2024/4393/P – 11 Murray Street

Delegated Report (Members Briefing)		Analysis sheet	Expiry Date:	05/12/2024
		N/A / attached	Consultation Expiry Date:	10/11/2024
Officer			Application Number(s)	
Gary Wong			2024/4393/P	
Application Address			Drawing Numbers	
11 Murray Street London NW1 9RE			Refer to draft decision notice.	
PO 3/4	Area Team Signature	C&UD	Authorised Officer Signature	
Proposal(s)				
Erection of a single storey rear extension and alterations to the windows and doors in the front lightwell.				
Recommendation(s):		Grant conditional full planning permission		
Application Type:		Full Planning Permission

Proposal: Erection of a single storey rear extension and alterations to the windows and doors in the front lightwell.

Figure 10 Proposed floor plans, elevations and sections (Source: submitted drawings)

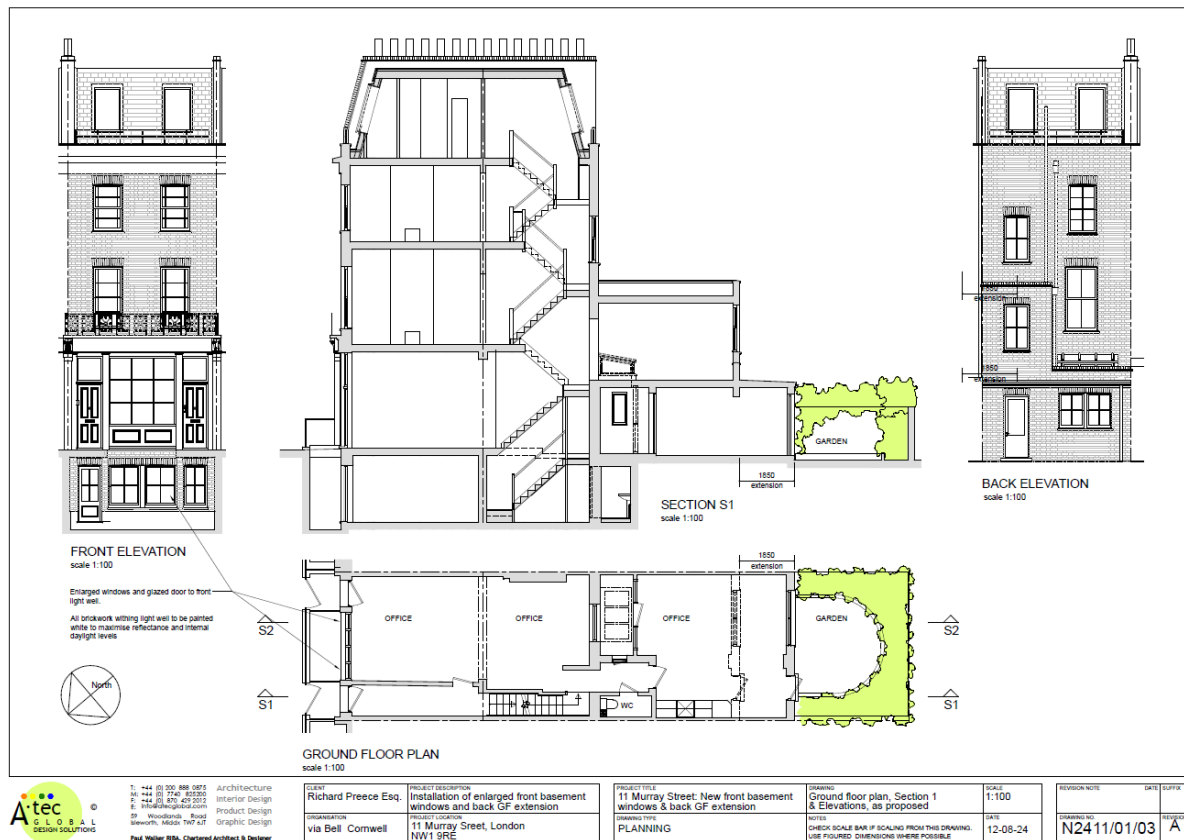
- The heritage report does not take into account that the extension is projecting beyond the existing building line at the rear. The proposed extension will be peculiar to it.
- The existing first floor plan does not show the extent of the new roof.
- The rear elevations in the proposed drawings do not show the proposed building. The existing garden wall is also not shown in the drawings and it is unclear where the proposal sits in relation to the neighbouring buildings.

- Numerous assertions of compliance are made in the Statement but not substantiated. The 'existing' and 'proposed' rear elevations appear identical; this conflicts with the plans and sections.

- *The proposal will extend the existing closet wing and ground floor infill extensions slightly further and the rear fenestration arrangement will remain the same as the existing. Therefore, the proposed rear elevation is considered to show this accordingly.*
- *Revised drawings have been submitted to include the existing and proposed roof plans and they are considered sufficient for full assessment on the proposal.*
- *Please refer to Section 2 for assessment on design and heritage impact.*

- *The applicant has clarified the proposal will extend the existing further rearward and the rear fenestration arrangement will remain the same to the existing. Therefore, the proposed rear elevation is considered to show this accordingly.*
- *Please refer to Section 2 for assessment on design and heritage impact.*
- *Please refer to Section 3 for assessment on amenity impact.*
